UNITED STATES PATENT AND TRADEMARK OFFICE

Office Action Summary	Application No. 10/824,124	Applicant(s) SHANLEY, JOHN F.	
	Examiner Vy Q. Bui	Art Unit 3773

DETAILED ACTION

Fig. 30

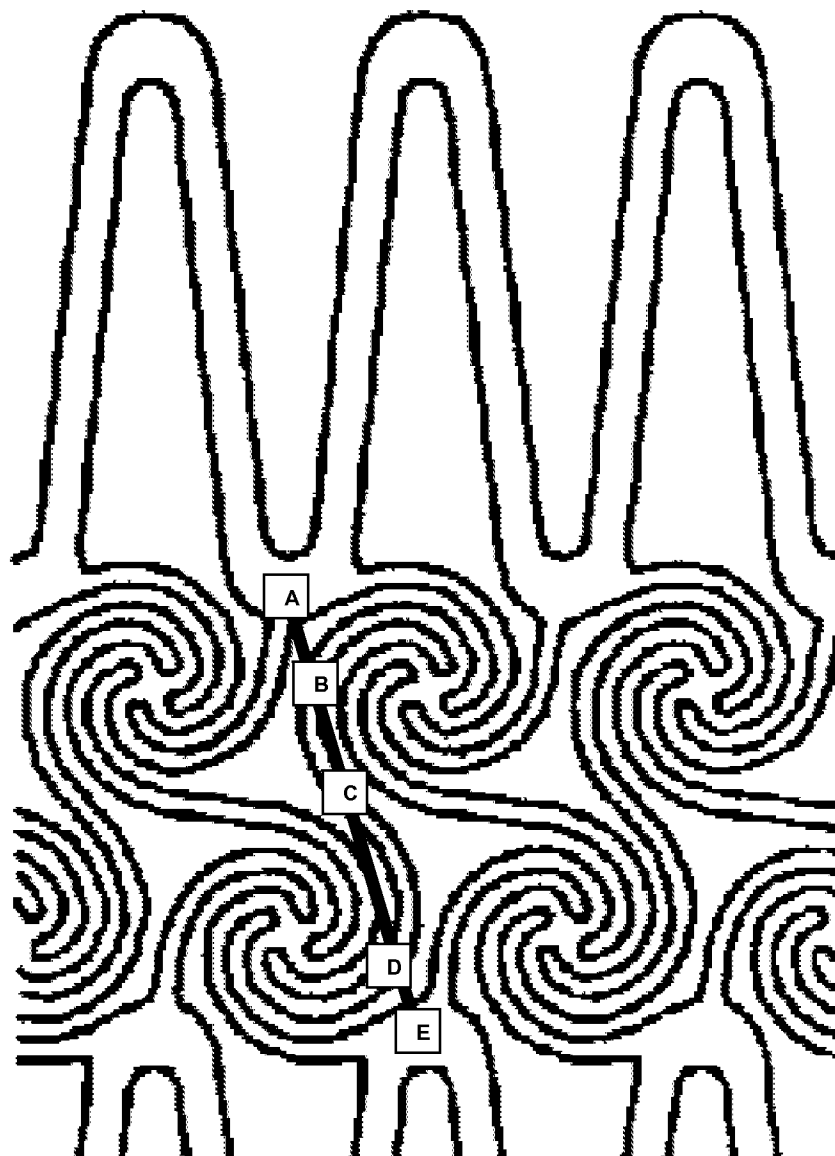
As to claims 1-3, 11-12, 14-17, Ehr-'433 (please refer to a portion of Fig. 30 reproduced on next page) discloses a stent having S-shape bridging elements crossing three times at locations B, C, D the midlines AE of V-shapes as recited in the claims. Notice that a line can be a curved line or a straight line (please see definition 2 of term "line", for example, from one page of www.dictionary.com attached), line ABCDE as shown in Fig. 30 below is actually on a cylindrical surface of a stent and indeed parallel to the longitudinal axis of the stent therefore meet the limitation as recited in claims 1 and 17.

Further as to claims 7 and 12, the curved section or alternate ends where two adjacent struts in a same cylindrical tube are reasonably considered as hinges and circumferential links because the Ehr-'433's stent expand occurs mainly at these curved sections/ alternate ends.

Further as to claim 9, end A is substantially at 180 degrees out of phase from end E.

The arguments suggested that the Ehr-'433 does not meet the limitation "a midline parallel to the longitudinal axis of the stent" as now recited in the independent claims 1 and 17.

However, the stent is basically of a cylindrical form, therefore midline ABCDE as shown in above "Ehr-'433's" Fig. 10 is indeed parallel to the longitudinal axis of the stent as recited in the claims.

It appears that the midline in the present invention is also a symmetrical line of a V-shaped apex where two adjacent struts in the same cylindrical tube interconnect. However, the claims do not provide any limitation to distinguish "a midline" in the claims and a midline ABCDE in "Her-'433" reference as shown above.

FIGURE 3

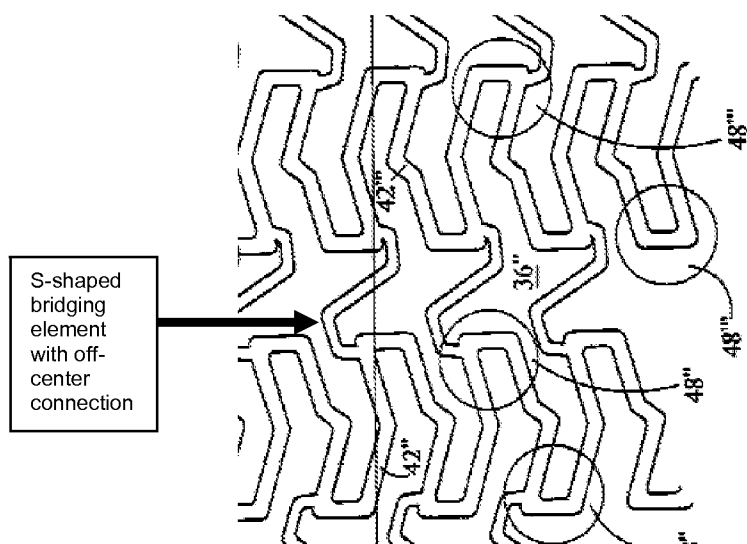
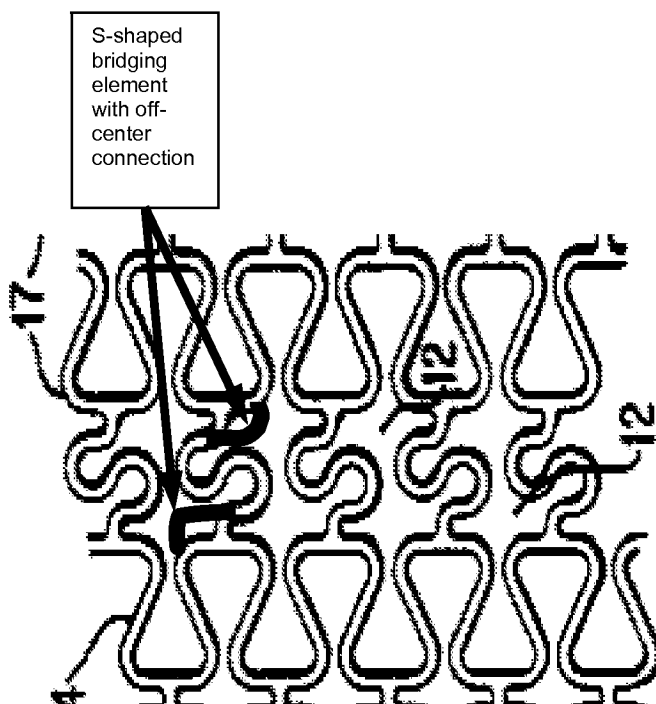
As to claims 1, 4, 13 and 17, Fischell-'971 (Figs. 2-3) discloses a stent 10 having cylindrical tubes having adjacent struts and S-shaped bridging elements substantially as recited in the claims, except for the connecting points of the S-shaped bridging elements located diagonally and bridging element less wider than strut as recited in the claims. However, Jang-'053 (Fig. 1-3, for example) discloses connecting points of the S-shaped bridging elements located diagonally (off-center connection) and S-shaped bridging elements less wider than adjacent struts. It would have been obvious to one of ordinary skill in the art at the time of the invention to move the connecting points to the locations as shown in modified Fischell-'971 stent in view of Jang-'053 (please, see Fig. 2 on next page) for this modified configuration provide Fischell-'971's S-shaped bridging elements longer, more flexible and having more stored length for expansion.
